## **PJM Response to MISO Capacity Deliverability Whitepaper**

**July 10, 2012**

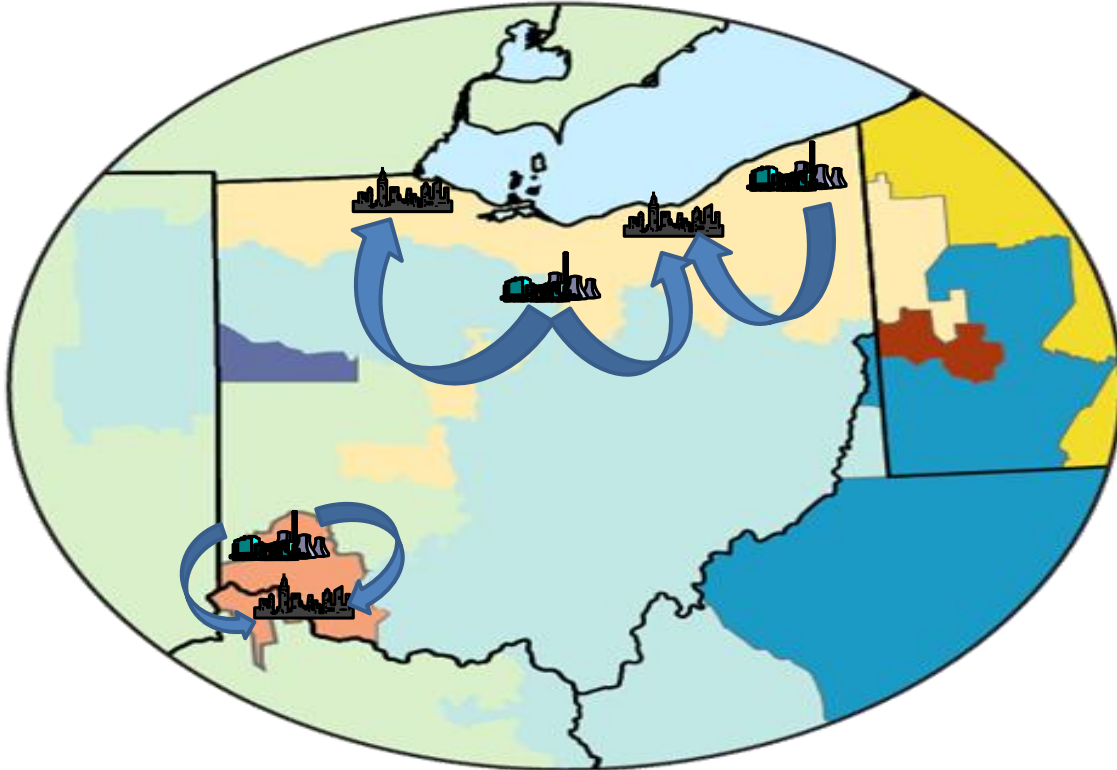
Additionally, the First Energy and/or Duke integrations into PJM do not demonstrate the existence of "institutional barriers" to the transfer of capacity across the seam. The generation resources in these zones are serving fundamentally the same load they were serving when the zones were in MISO. New "transfers" of capacity to the PJM footprint are not available due to these zones' move from MISO to PJM. In short, the MISO paper only looks at half the equation i.e. generations deliverability before and

after the First Energy integration while ignoring the fact that the load which is served by that generation also moved to PJM thus maintaining the balance that existed when that same level of generation and load was all in the MISO region.

First Energy and Duke generation AND load transferred to PJM.

Resources in the zones largely serve the same load; new “transfers” of capacity are not suddenly available that were not before.
